# **Preliminary Plat approval for Autumn Woods**

**PRELIMINARY PLAT  
A Re-Plat of Lot 1, Block 5, Neff Lakes  
'AUTUMN WOODS'**

**CASE #PP14-23**

**CASE #PDP14-23**

LANDSCAPE PLAN

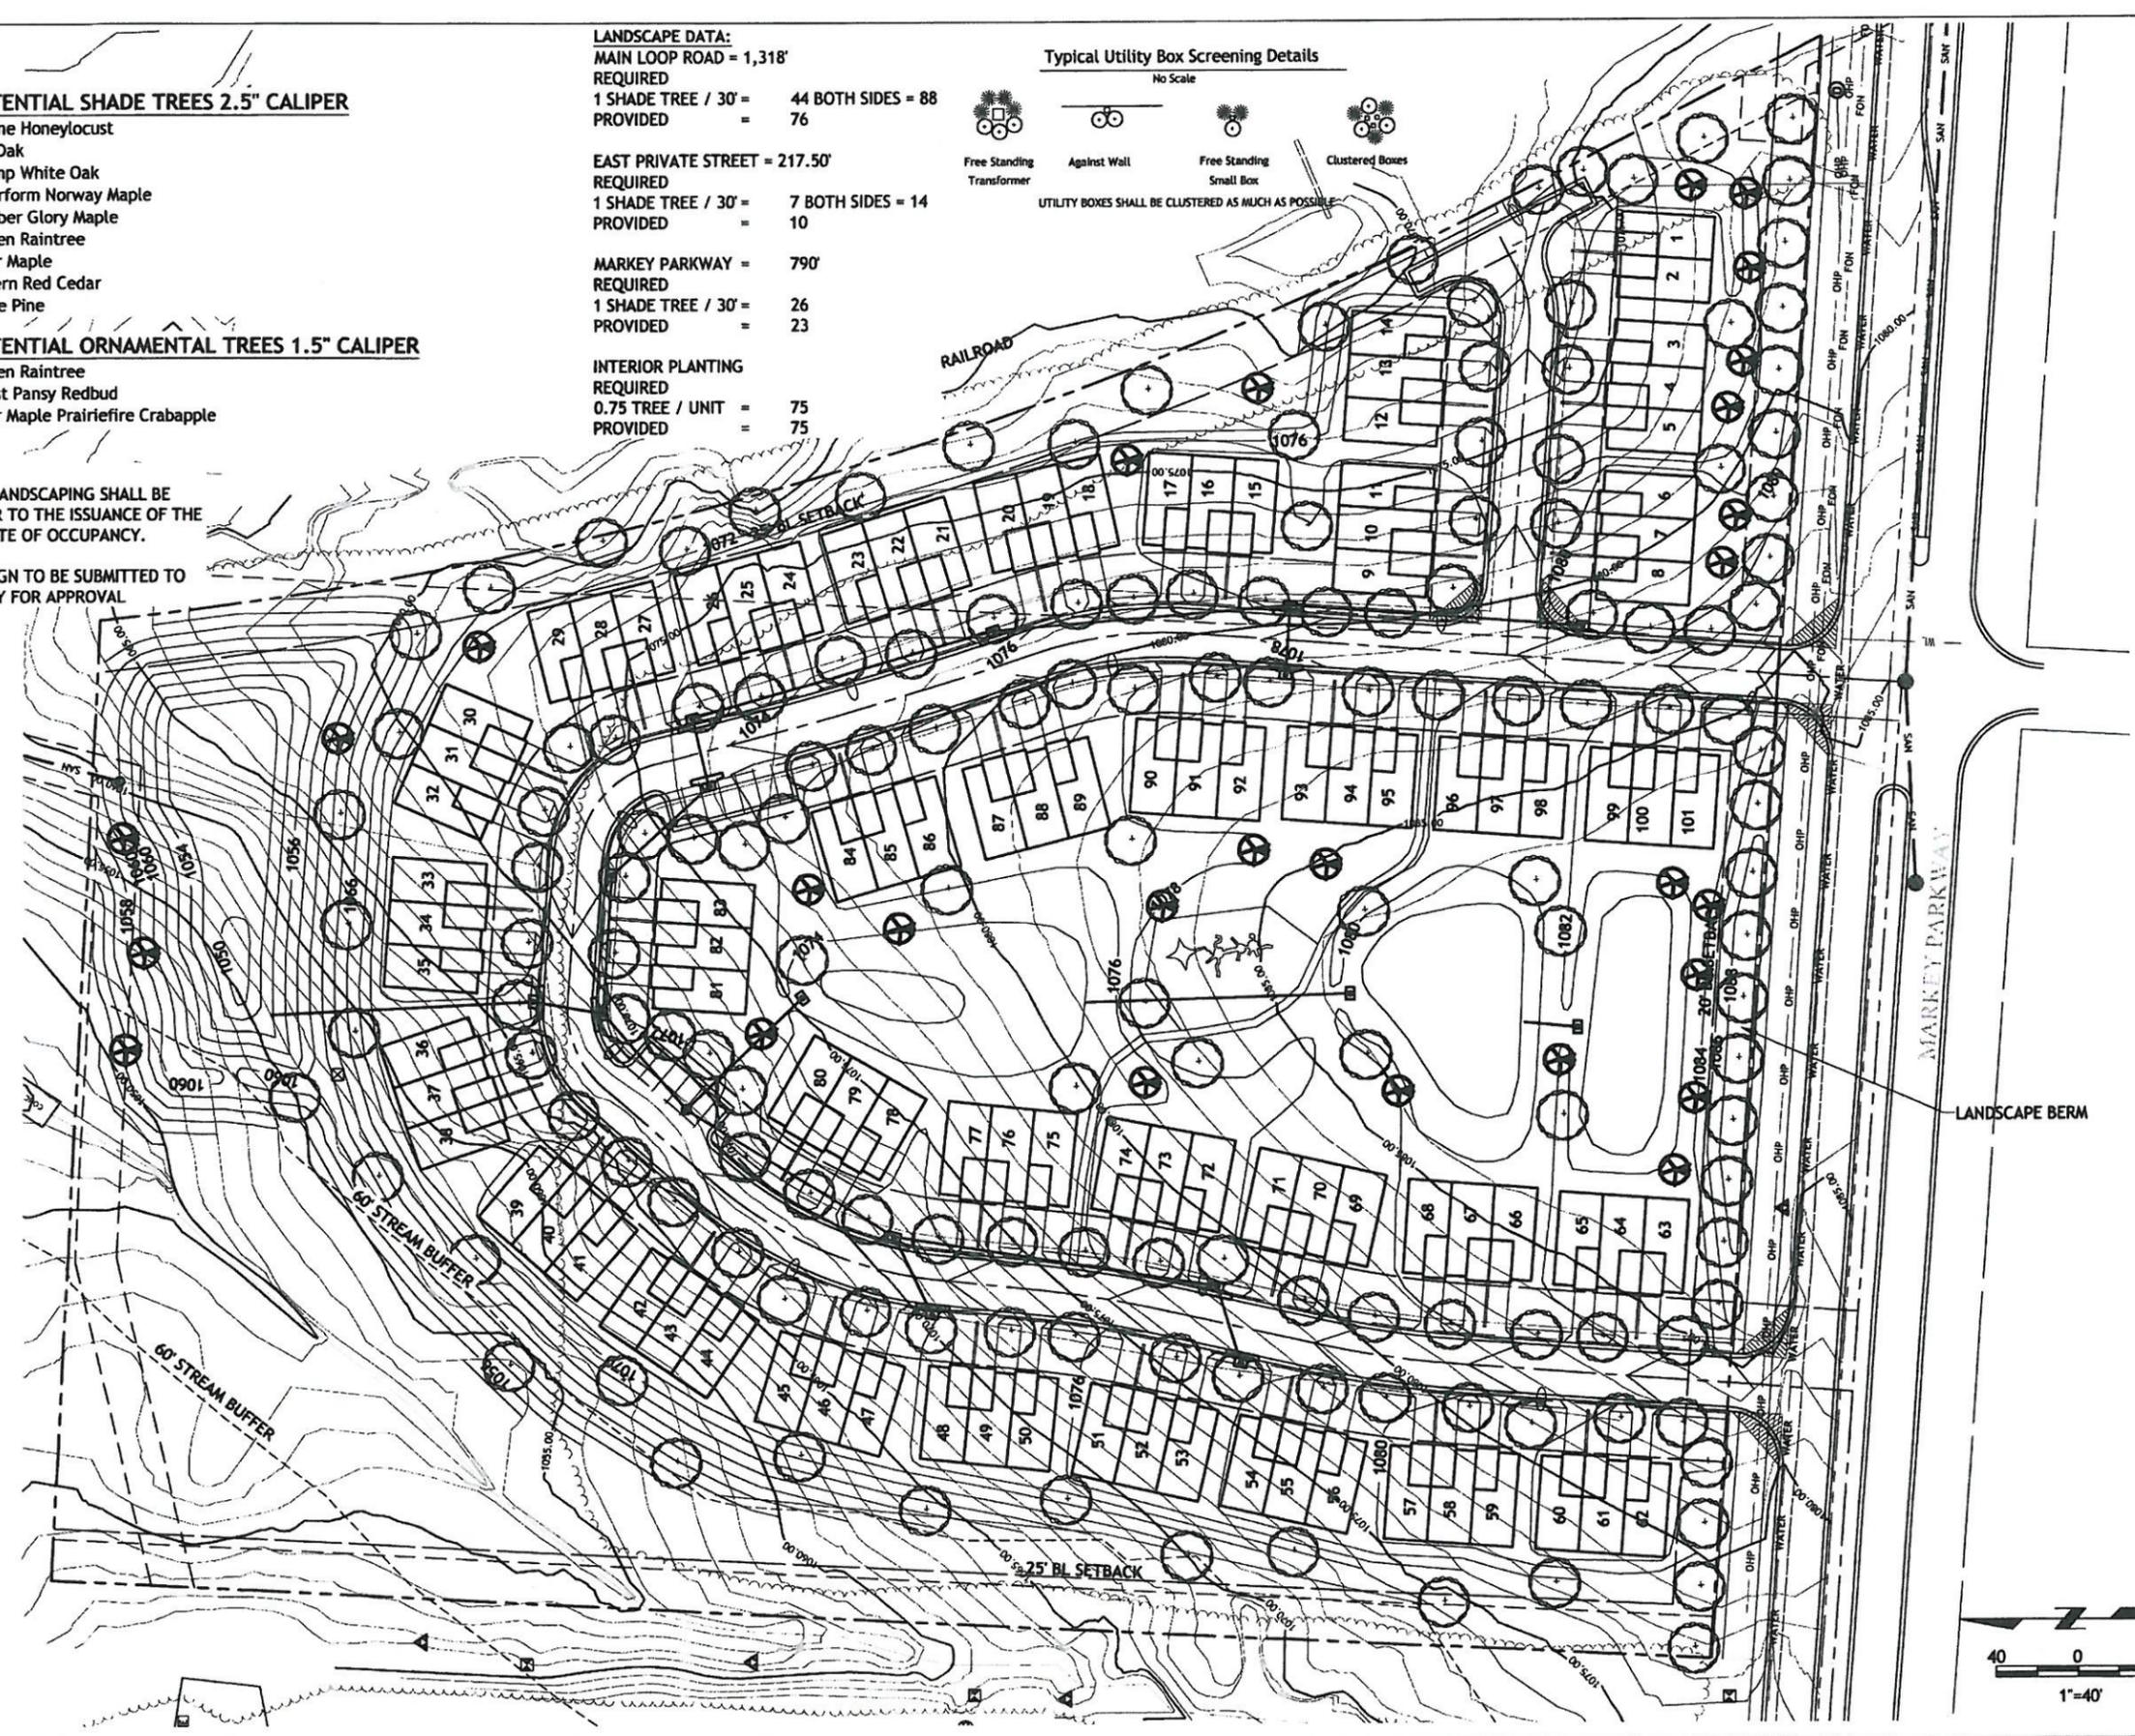
- Notation of all areas to be seeded and sodded;
  - Provide details on landscaping irrigation system, including a back-flow preventer;
  - Proposed deciduous trees shall be at least 2.5” caliper in size;

- Proposed ornamental trees shall be at least 1.5” caliper in size;
  - Provide a landscape berm along Markey Road;
8. All off-street parking areas are required to have concrete curb and gutter;
